STAFF RECOMMENDATION

1018 Acklen Avenue

August 19, 2020

Application: New Construction – Addition

Figure 1. 1018 Acklen Avenue, August 2020.

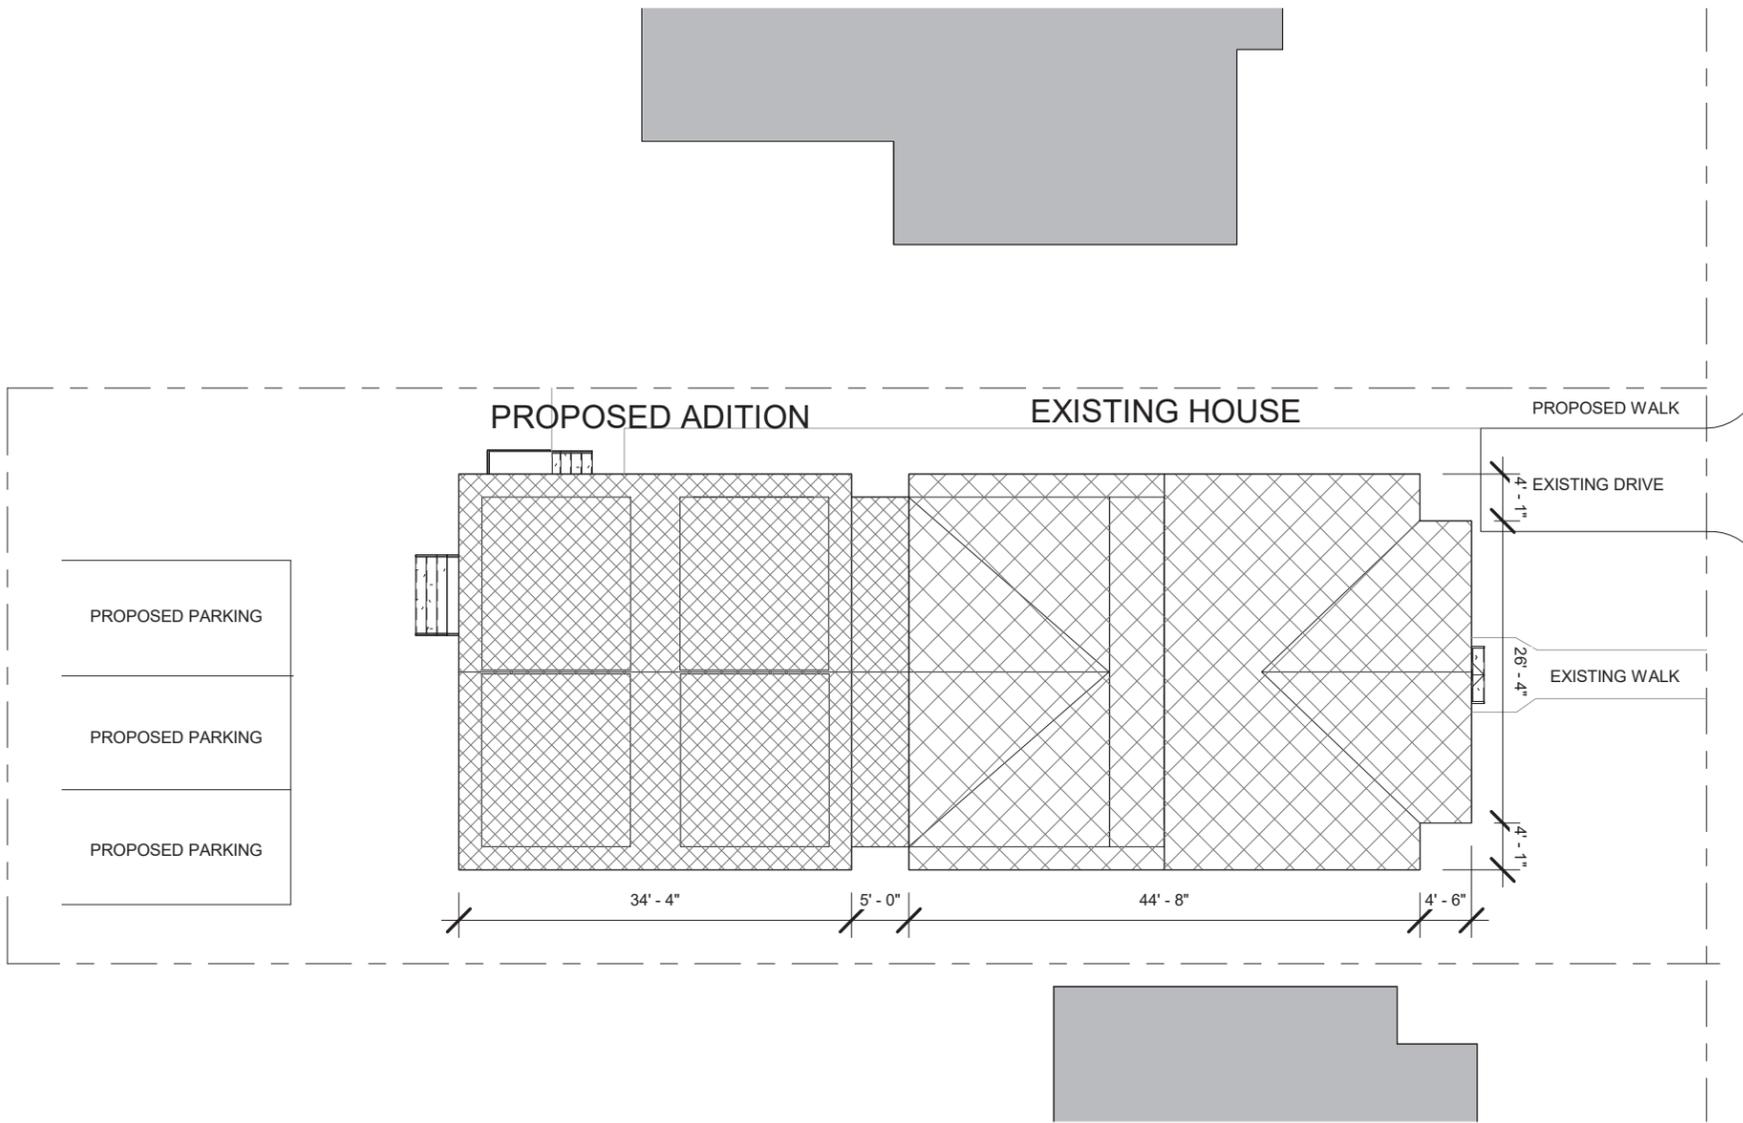
Height & Scale: The addition incorporates a ridge raise, which can be appropriate since the primary roof form of the house is a side gable. The front porch has a front gabled roof form, but it does not tie into the primary ridge of the house. The ridge raise extends two feet (2') taller than the historic house with the side eaves and walls set in two feet (2'), in accordance with the design guidelines.

The proposed rear addition is no wider than the historic house and does not more than double the footprint. As proposed the addition will add approximately one thousand eighty-nine square feet (1089 sq. ft.) to the existing footprint of approximately one thousand, one hundred two square feet (1102 sq. ft.). The addition is set in two feet (2') from both rear corners and goes back nine feet (9') before coming back out to match the width of the historic house. The addition ties into the rear roof one foot, eleven inches (1'-11") below the ridge of the historic house.

Roof form: With the ridge raise, the roof form of the addition will be a cross-gable form with pitches of 5/12 and 6/12 that are compatible with the roof slope of the historic house. The plan incorporates two shed dormers on each side of the addition. All four dormers are set in two feet (2') from the wall below to meet the design guidelines and have a pitch of approximately 2/12.

Proportion and Rhythm of Openings: No changes to the window and door openings on the existing house were indicated on the plans. Most of the windows on the proposed addition are all generally twice as tall as they are wide, thereby meeting the historic proportions of openings. There are three smaller, square windows on the right-side façade of the addition; staff finds that the square windows can be appropriate since they are located closer to the rear of the addition. There are no large expanses of wall space without a window or door opening.
